STATE OF NORTH CAROLINA
DEPARTMENT OF TRANSPORTATION

Subject: Request for Modification to Individual Section 404 and Section 401 Water Quality Certification for widening and new lane construction from US 74 Rockingham/Hamlet Bypass to US 220 Ellerbe Bypass in Richmond County. Federal Aid Project No. NHF-0220(4), State Project No. 8.1580802, Division 8, TIP Nos. R-3421A and B.

The purpose of this letter is to submit final drawings for modification of the Clean Water Act (CWA) Section 404 Individual Permit (IP) and Section 401 Water Quality Certification for R-3421A and B. Preliminary drawings for these sections were submitted with the original phased permit application.

SITE 8A SITE 8

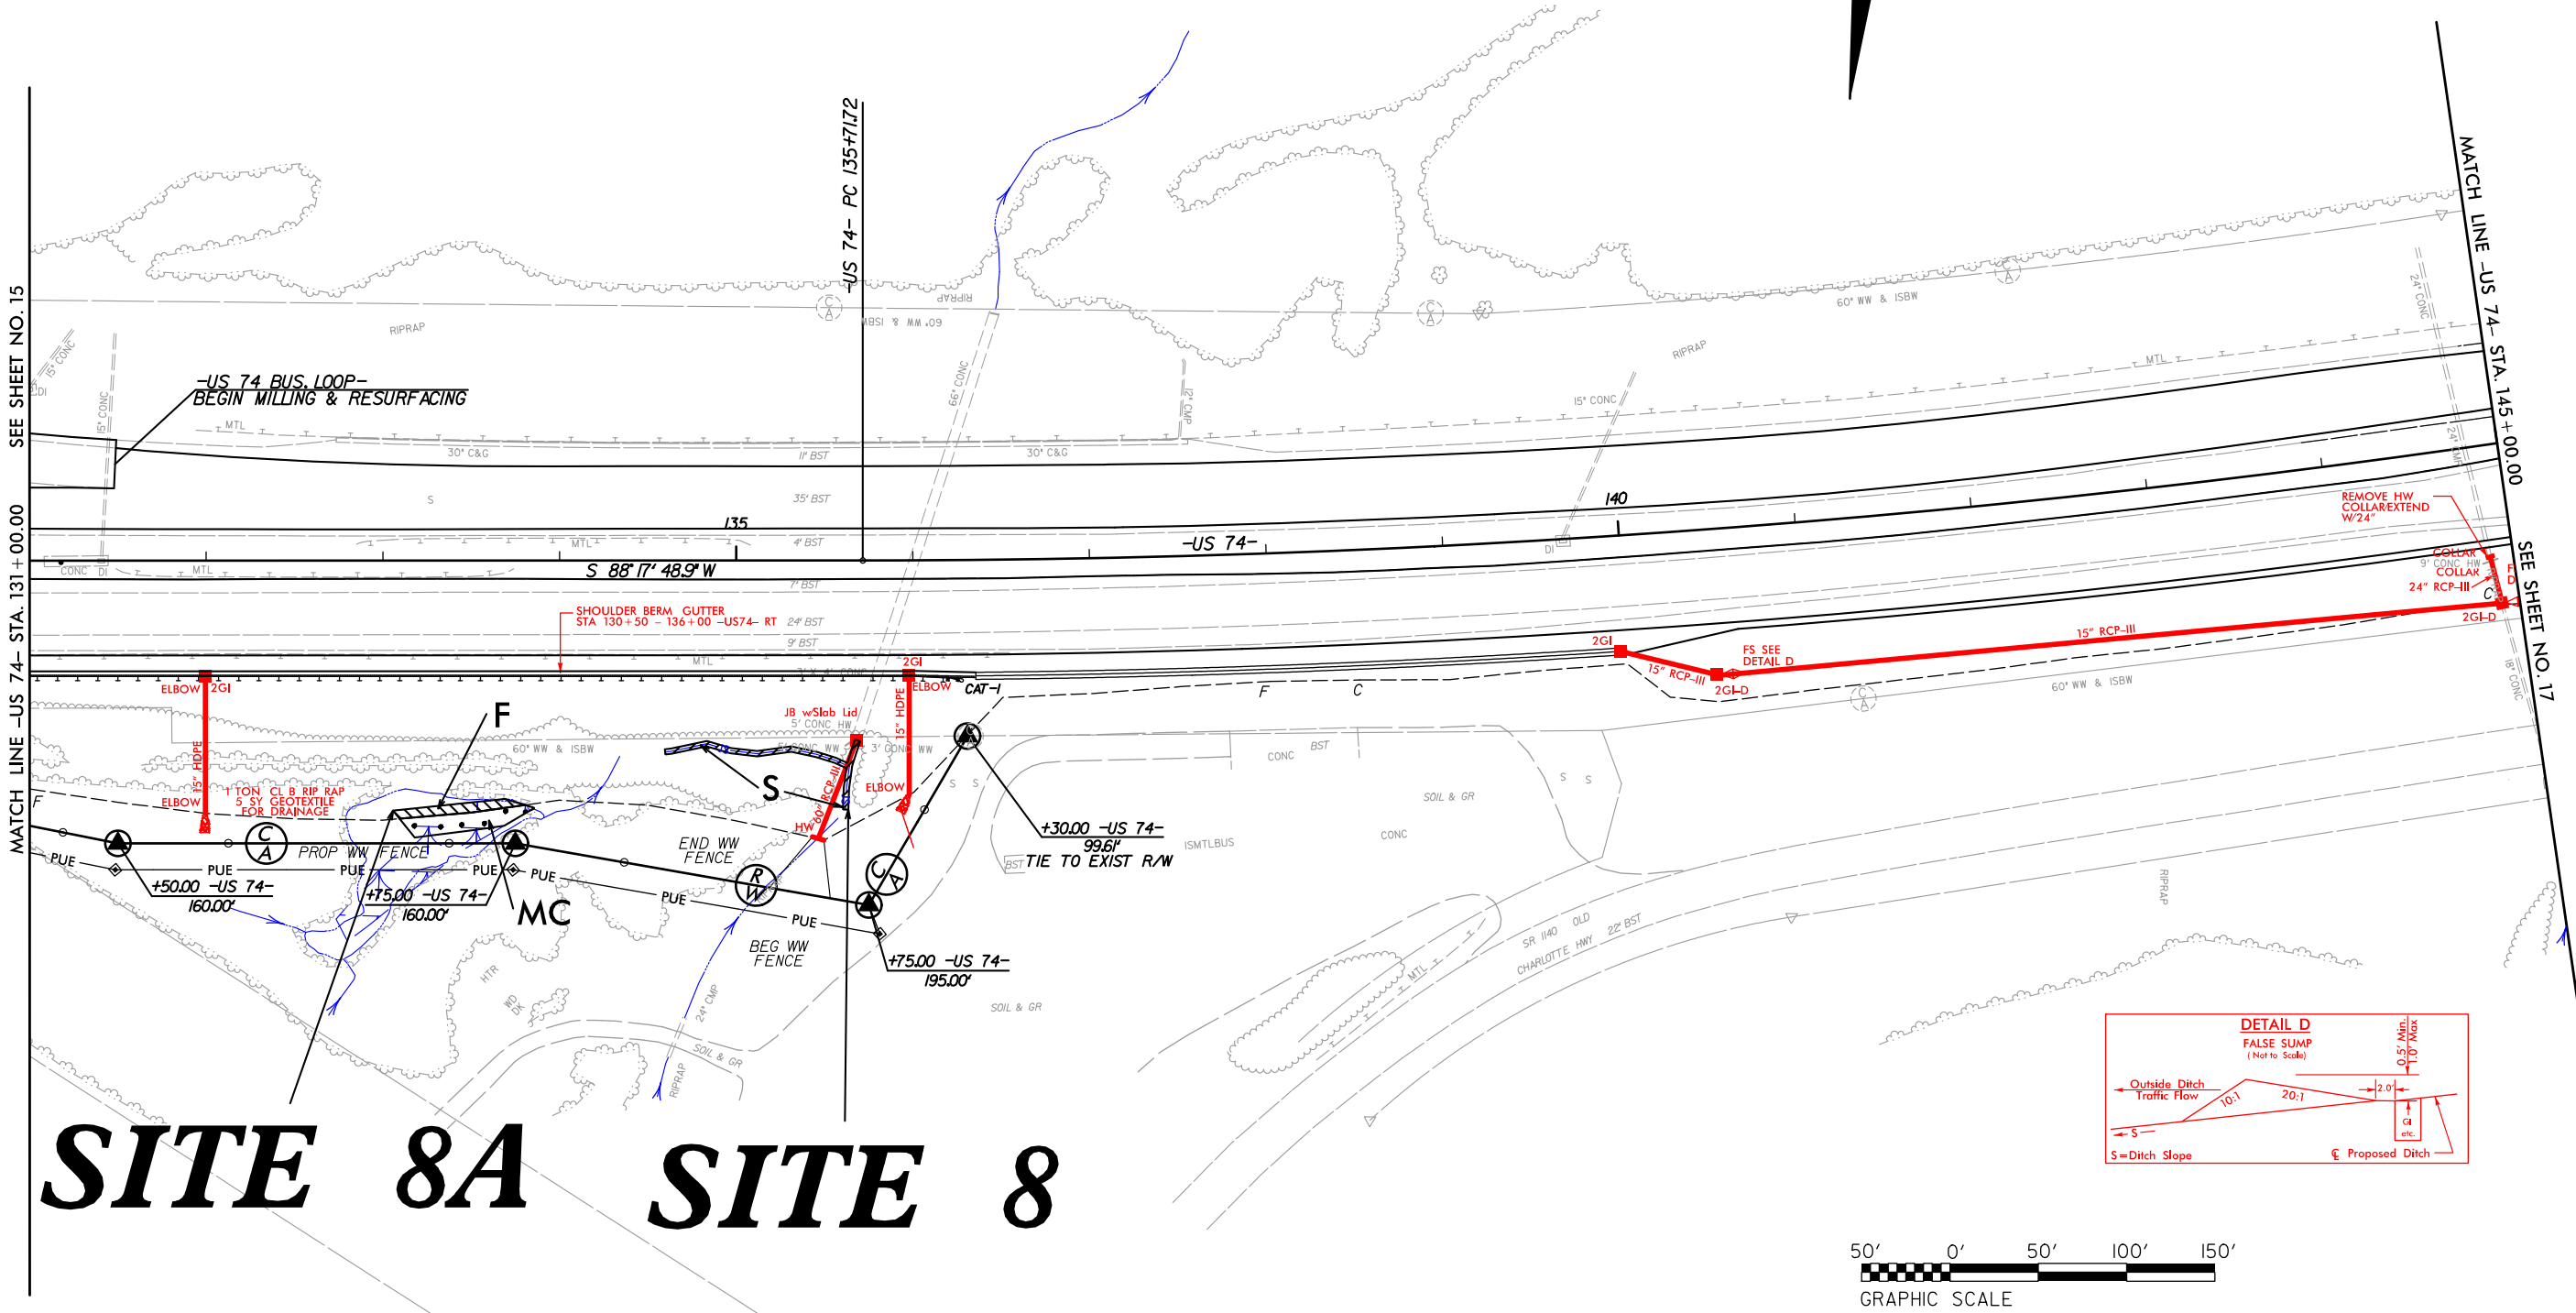
- For clarification, label stream location between the culverts.
 - Show stream cross section and detail.
11. Site 8/8A
 - Add notation for beginning of JS.

- Note that pond has been drained.
